# Access Compliance Report

## Public Rights-of-Way

### (Curb Ramps)

Intersection ID: 47610	Main Street: BATHURST_DR	Cross Street: MINTWORTH_AV	Location: NE
ADA ID: 543EE2104621	Ramp Type: PerpDiag	Initial Pass/Fail: Fail	Overall Compliance: No
		Severity Score: 12.5

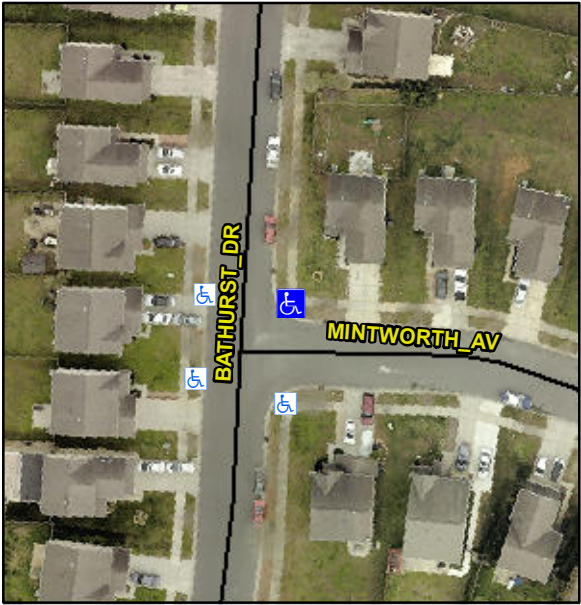
Codes/Mitigation Info/Possible Solution			Field Measurements/Component Compliance		
	Possible Solutions:		<b>Compliance</b>	<b>Description</b>	<b>Data</b>
	<b>Remove &amp; Replace Curb Ramp With Two New Directional Ramps or Equivalent.</b>		<b>No</b>	Ramp Length (in)	69.0
			<b>Yes</b>	Ramp Width (in)	48.0
			<b>N/A</b>	Flare Type LT	N/A
			<b>N/A</b>	Flare Slope LT (%)	N/A
			<b>N/A</b>	Flare Traversable LT?	N/A
			<b>N/A</b>	Landing Length (in)	N/A
			<b>N/A</b>	Landing Width (in)	N/A
			<b>N/A</b>	Landing Slope (%)	N/A
			<b>N/A</b>	Landing X Slope (%)	N/A
<p>Surveyor Notes:</p> <p><b>N/A</b></p> <p>PROW/ADA:</p> <p><b>R304.2.2</b></p>			<b>N/A</b>	Flare Type RT	N/A
			<b>N/A</b>	Flare Slope RT (%)	N/A
			<b>N/A</b>	Flare Traversable RT?	N/A
			<b>N/A</b>	DWS Provided?	N/A
			<b>N/A</b>	DWS Contrast?	N/A
			<b>N/A</b>	DWS Length (in)	N/A
			<b>N/A</b>	DWS Full Width?	N/A
			<b>N/A</b>	DWS Offset (in)	N/A

<b>N/A</b>	Gutter Ponding?	N/A
			<b>N/A</b>	Gutter Lip Ht (in)	N/A
			<b>No</b>	Painted X Walk1?	N/A
			<b>To NW</b>	X Walk 1 Direction	To SW
			<b>N/A</b>	X Walk 1 Width (in)	N/A
			<b>2.3</b>	X Walk 1 Slope (%)	0.9
			<b>1.4</b>	X Walk 1 X Slope (%)	1.1
			<b>N/A</b>	Ramp inside XWalk1?	N/A
			<b>1.3</b>	Road Slope (%)	N/A
			<b>2.2</b>	Road X Slope (%)	N/A
			<b>N/A</b>	Any Obstructions?	N/A
			<b>N/A</b>	Obstruction Type	N/A
Total Cost:		\$ 3200.00	<b>N/A</b>	Clear Space?	N/A
			<b>N/A</b>	Clear Space to XWalk (in)	N/A
			<b>N/A</b>	Storm Grate/Utility Hazard?	N/A
			<b>N/A</b>	Storm Grate/Utility Type	N/A
			<b>Yes</b>	Surface Condition? (G/P)	Good
